RE: Request for Proposal RFP No. 420-25-01, School Entrance/Egress Restoration at School 23, Family School 32 and Enrico Fermi School and Lincoln High School

ADDENDUM No. 2:

ADDENDUM No. 1:

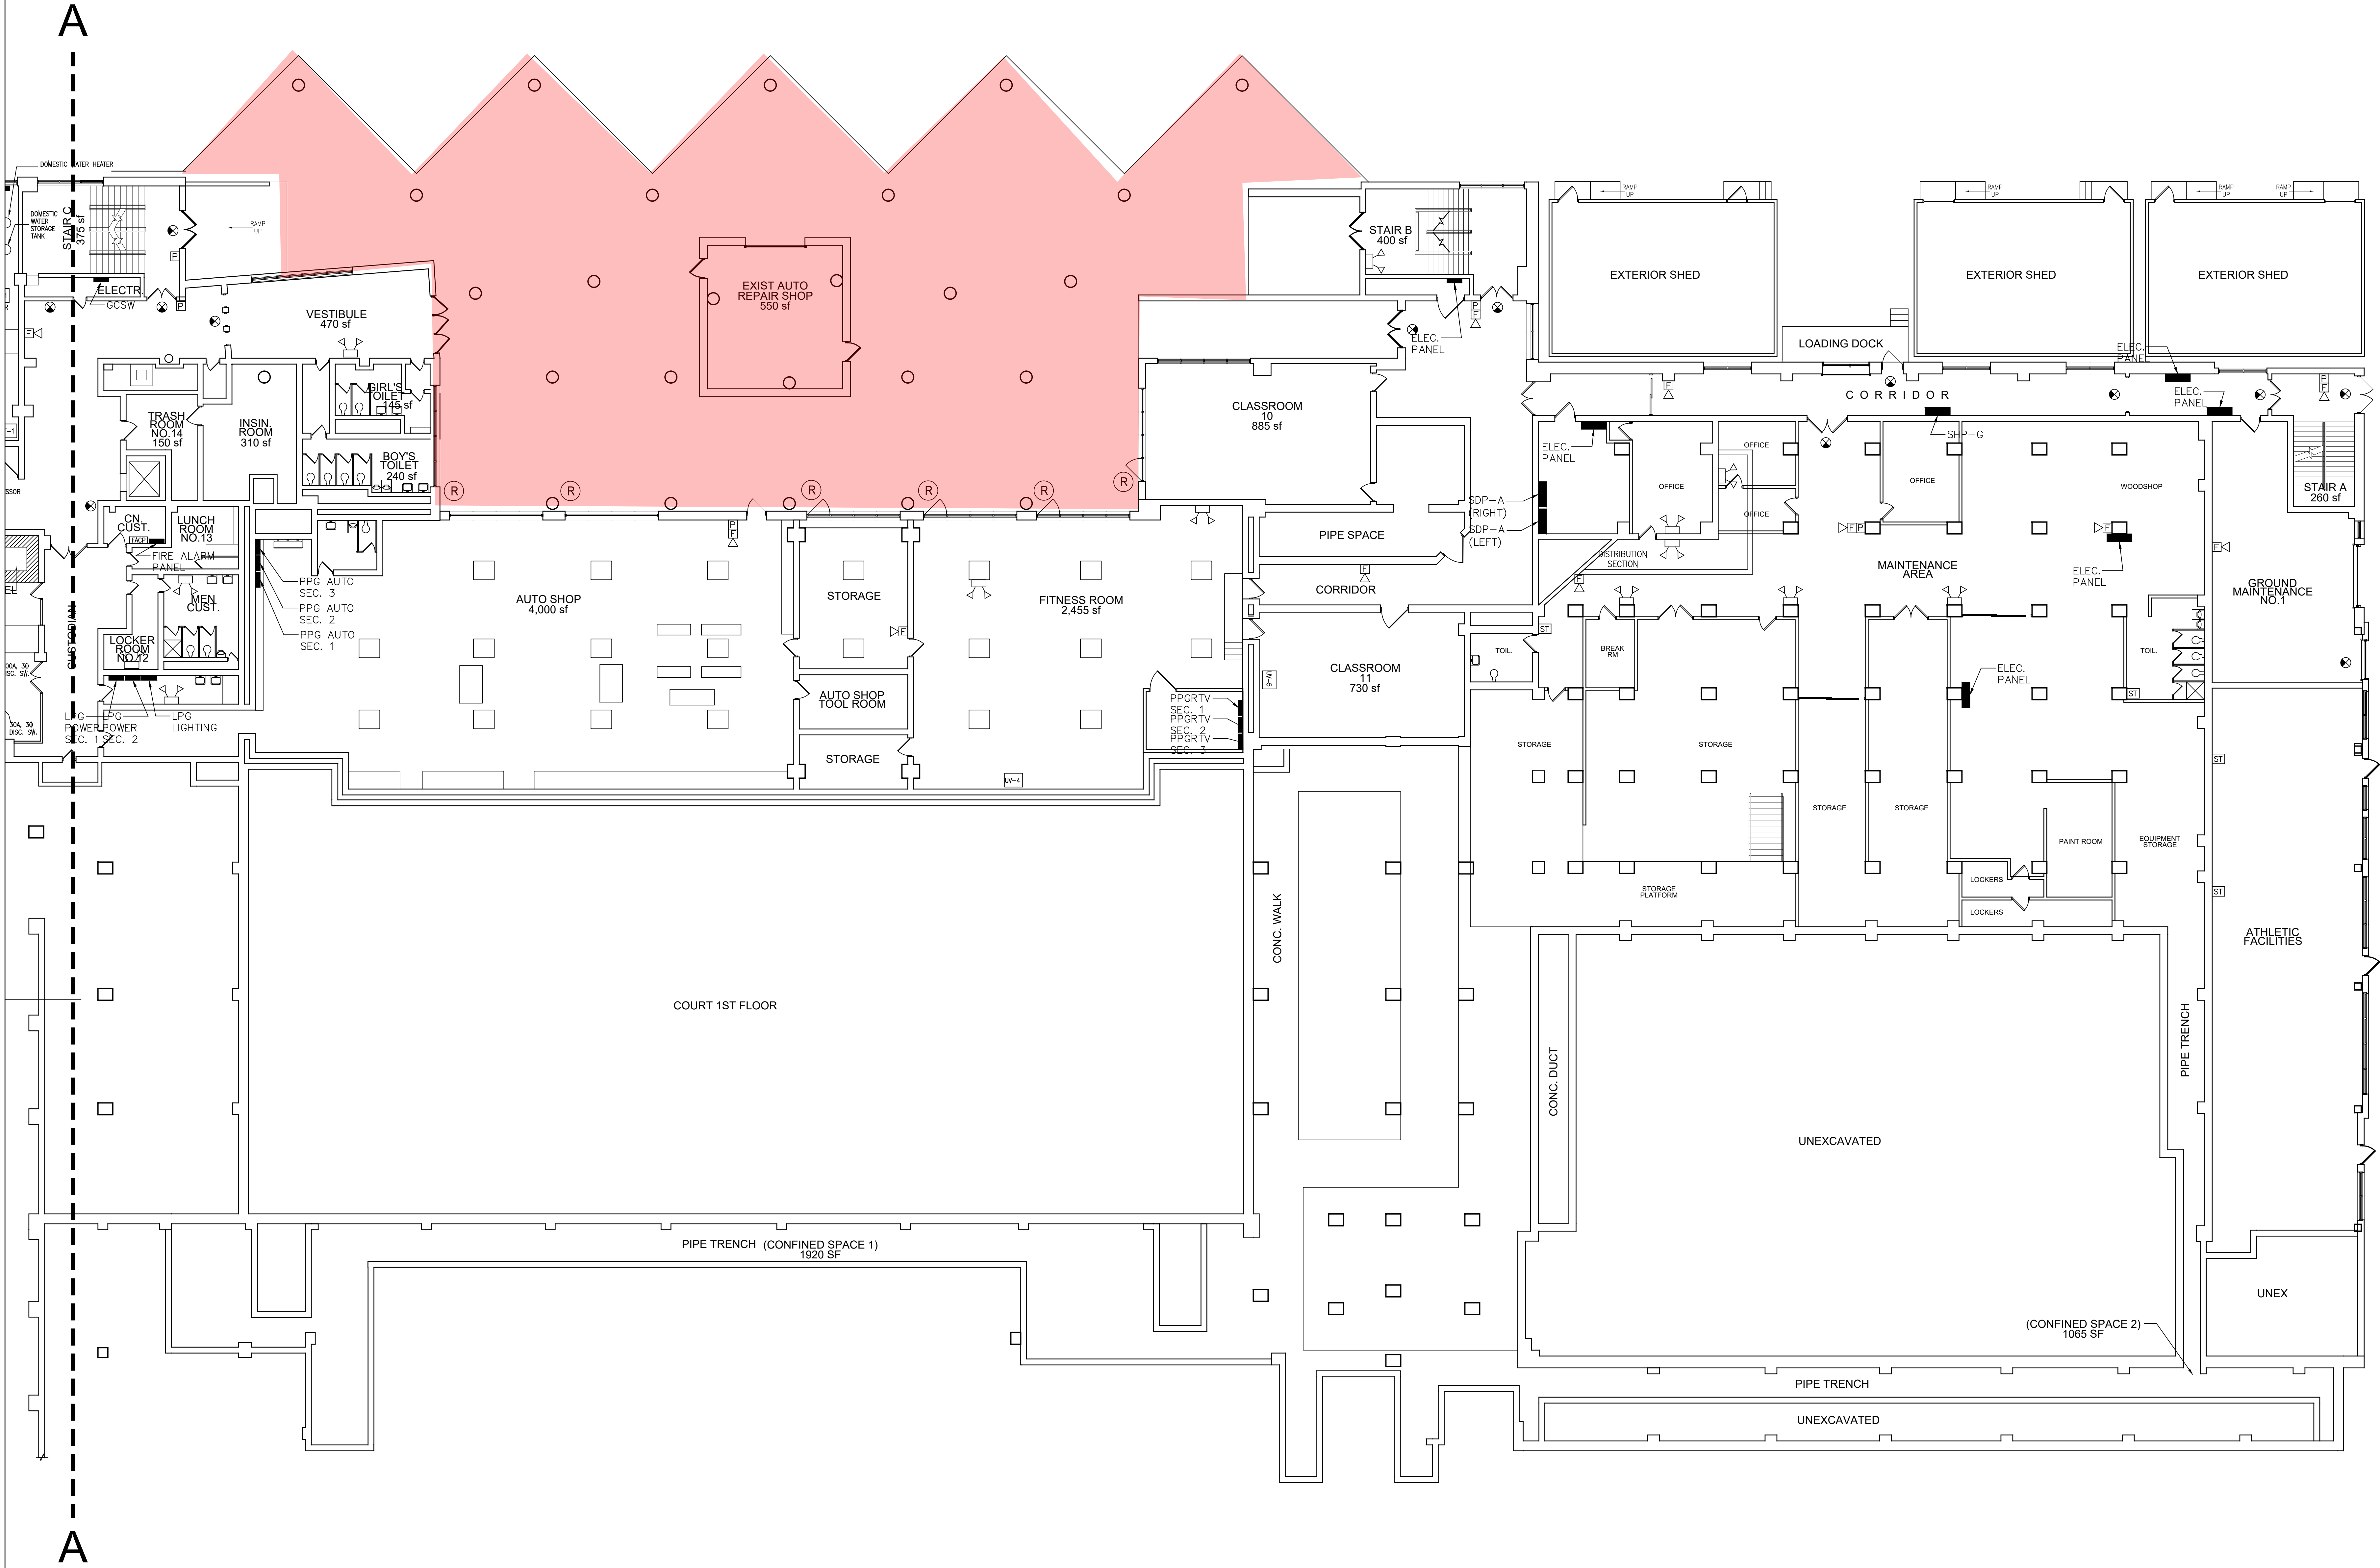
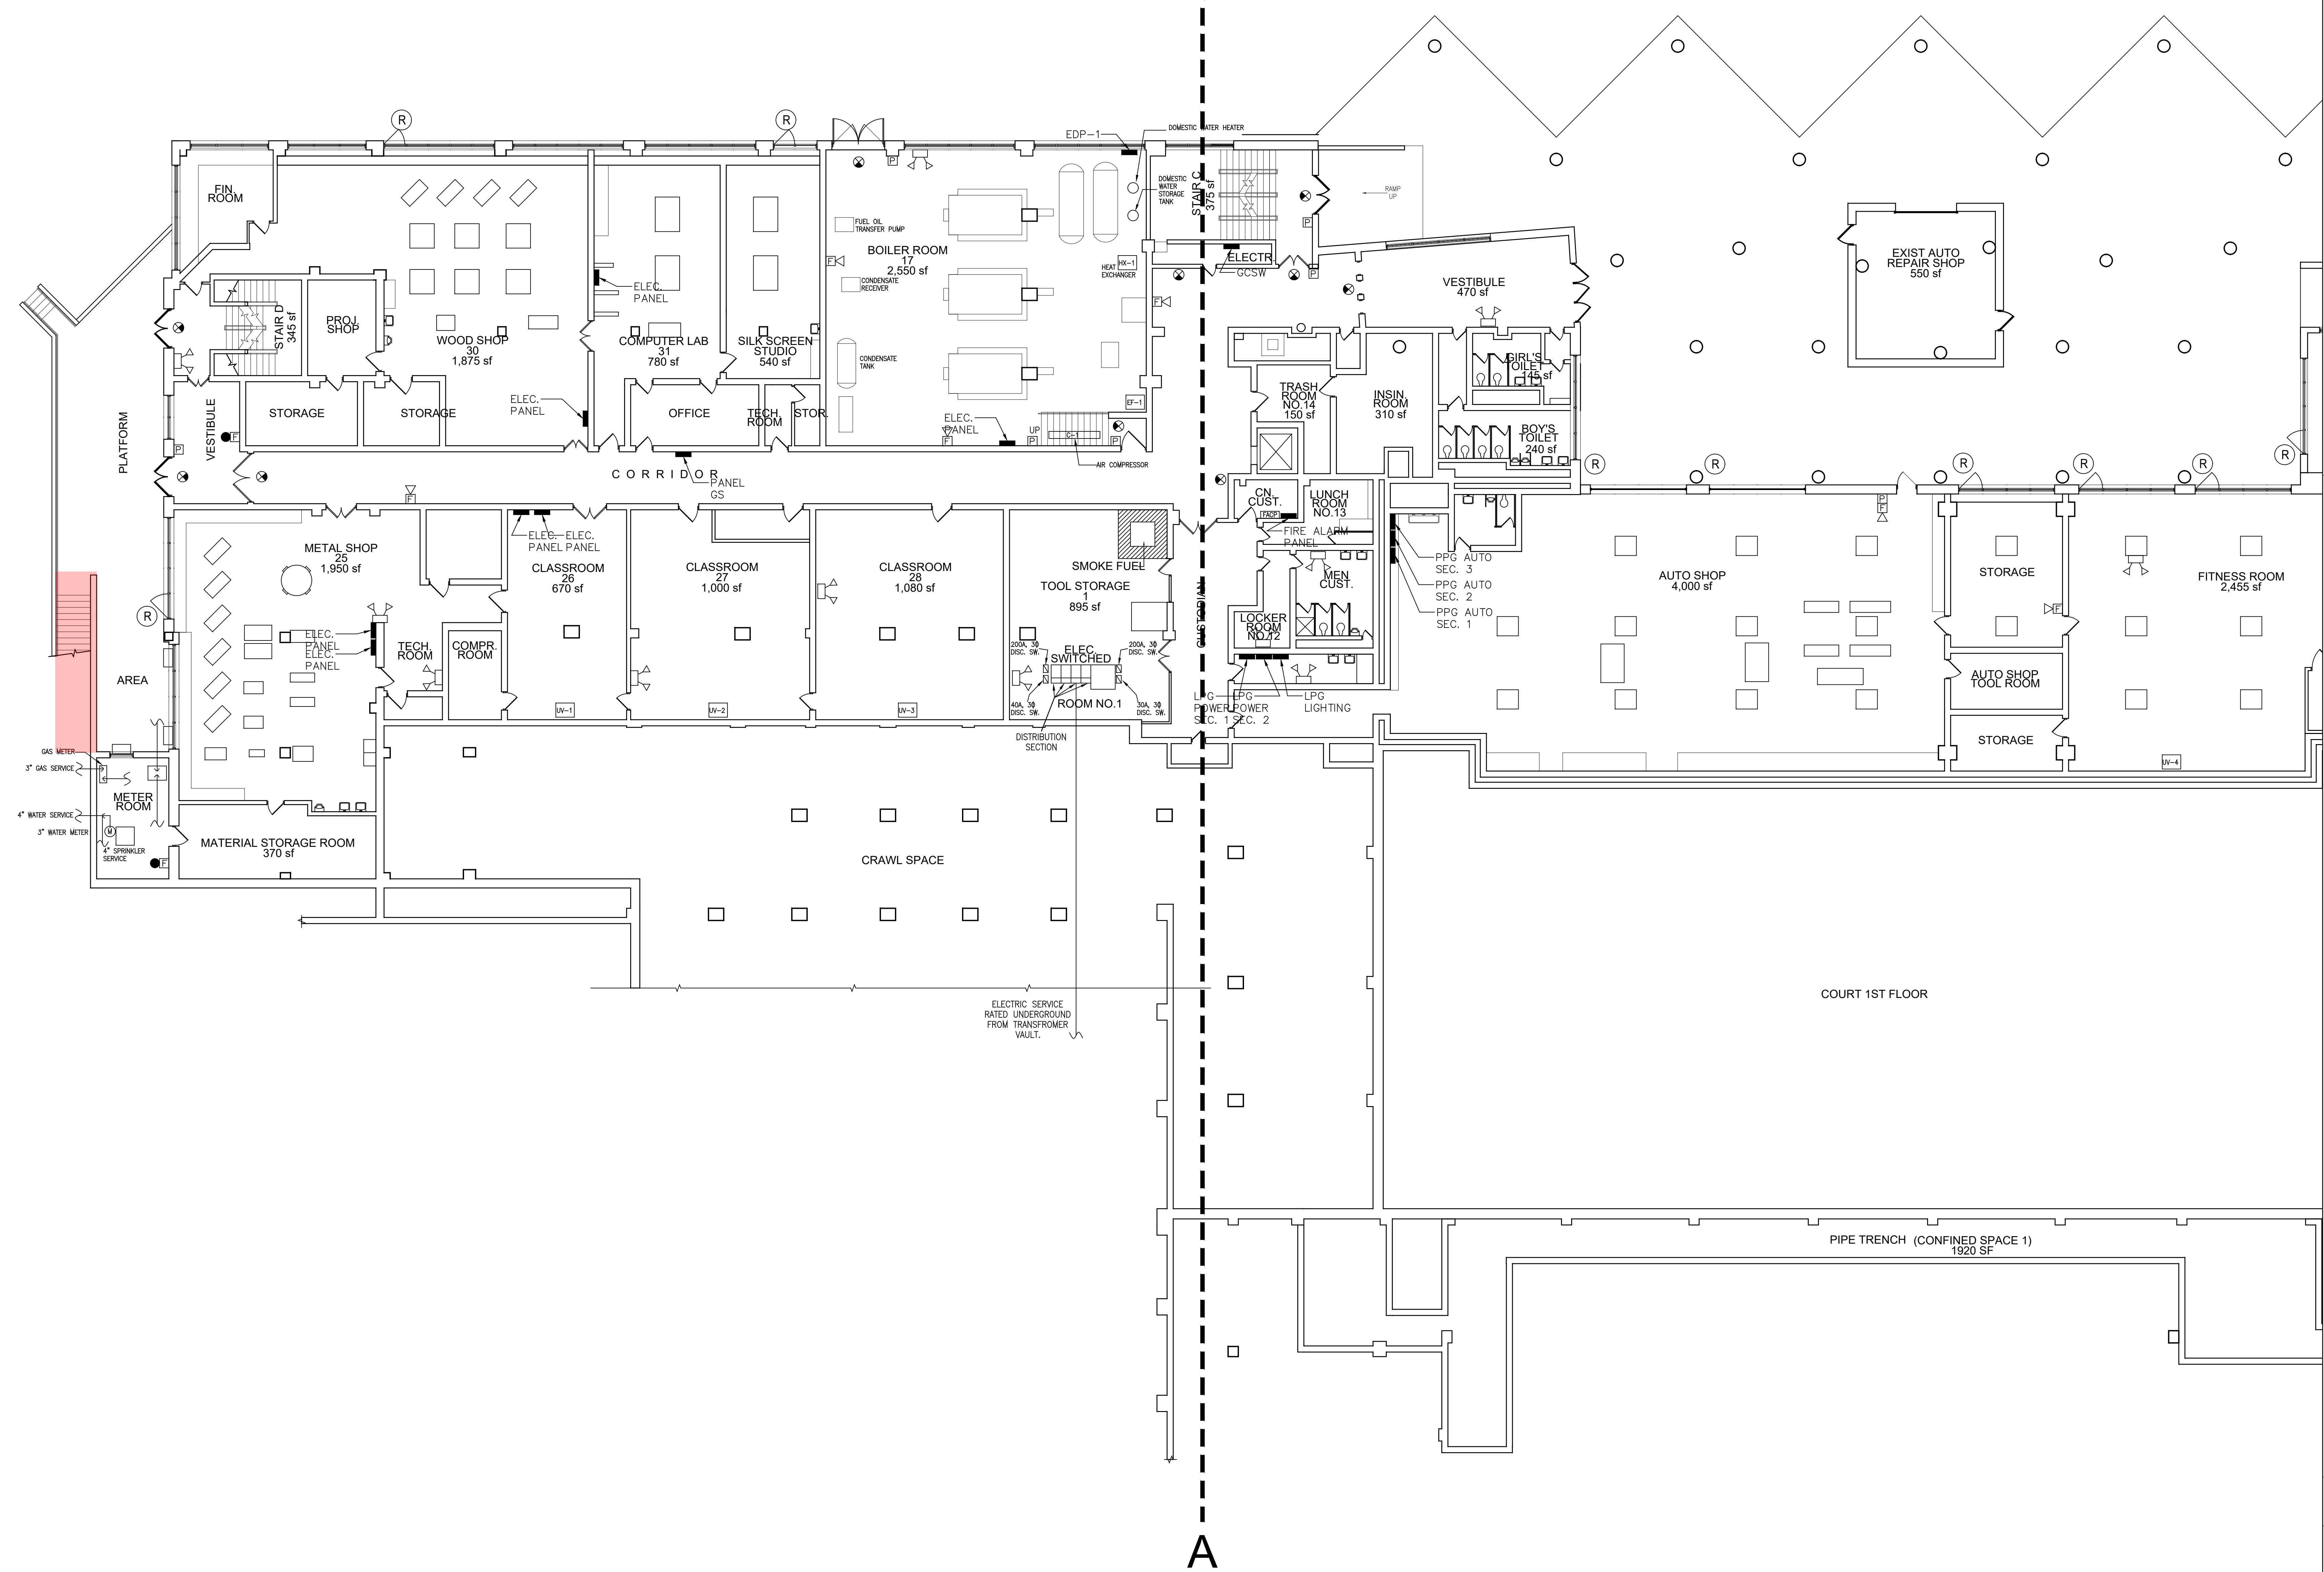
1. The Consultant shall include concrete stair replacement and masonry column repairs at the Lincoln High School.

The concrete stairs to be replaced are the stairs at the south end of the building allowing travel from the Staff Parking lot to the Ground Floor Shop Classroom egress area.

The consultant will be required to perform the structural investigations and designs for the repairs to the concrete columns supporting the overhanging saw-toothed classrooms.

See 2020 BCS drawings included with this addendum.
